WSJ2– Reworking Rear Axle Module Wire Harness (Workshop Campaign)

Vehicle Type: **Macan 4S (XAB)/Macan Turbo (XAB)**

Concerns: **Rear axle module wire harness**

Installation position

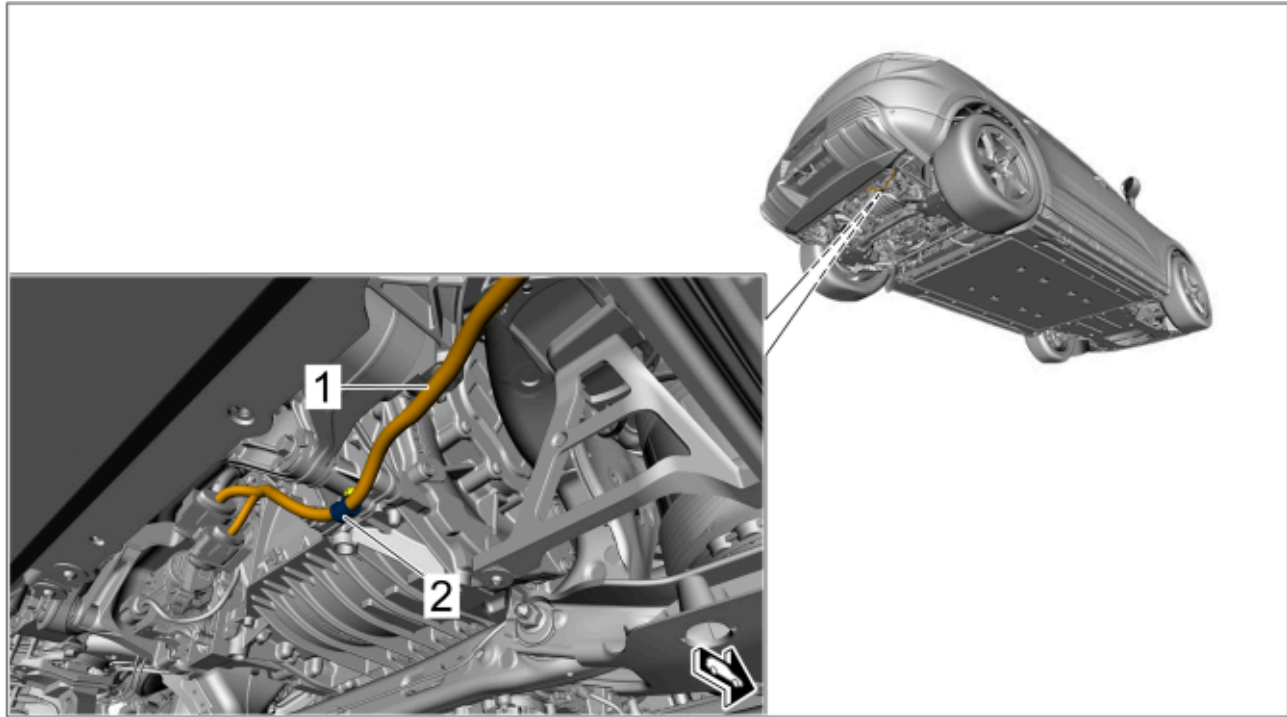
- 1 – Rear axle module wire harness (**check**)
- 2 – Fastening clip (**replace**)

Wire harness on rear axle module

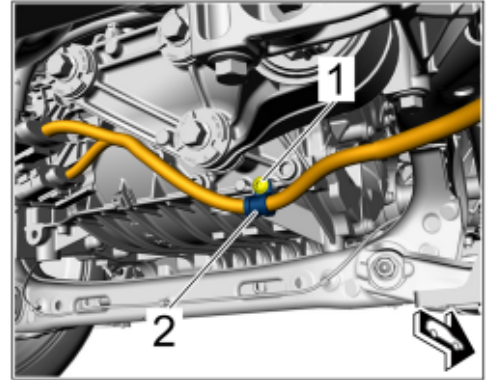
Assessment		Action
(✓)	The rear axle module wire harness in the area of the fastening clip is undamaged .	The rear axle module wire harness is OK . Continue with Step ⇒ 5.
(✗)	The rear axle module wire harness damaged in the area of the fastening clip. ⇒ <i>The rear axle module wire harness is not OK.</i> 	The rear axle module wire harness is not OK . Repair damaged lines for the rear axle module wire harness. For procedure, see: ⇒ <i>Technical Information '970941 Repairing electric lines on main wire harness'</i> Information: The diameter of the repaired rear axle module wire harness must be the same as the diameter of the original rear axle module wire harness in the area of the fastening clip. Then continue with Step ⇒ 5.

- 5 Install a **new** fastening clip for rear axle module wire harness ⇒ *Wire harness on rear axle module -2-*.
 - 5.1 Install and align **new** fastening clip ⇒ *Wire harness on rear axle module -2-* to the rear axle module wire harness.
 - 5.2 Screw in and tighten screw ⇒ *Wire harness on rear axle module -1-*.
Tightening torque 10 Nm (7.4 ftlb.)
- 6 Install the rear cover.
⇒ *Workshop Manual '519419 Removing and installing rear cover'*
- 7 Lower the vehicle.
⇒ *Workshop Manual '4X10IN Vehicle raising information'*
- 8 Enter the campaign in the Warranty and Maintenance logbook.
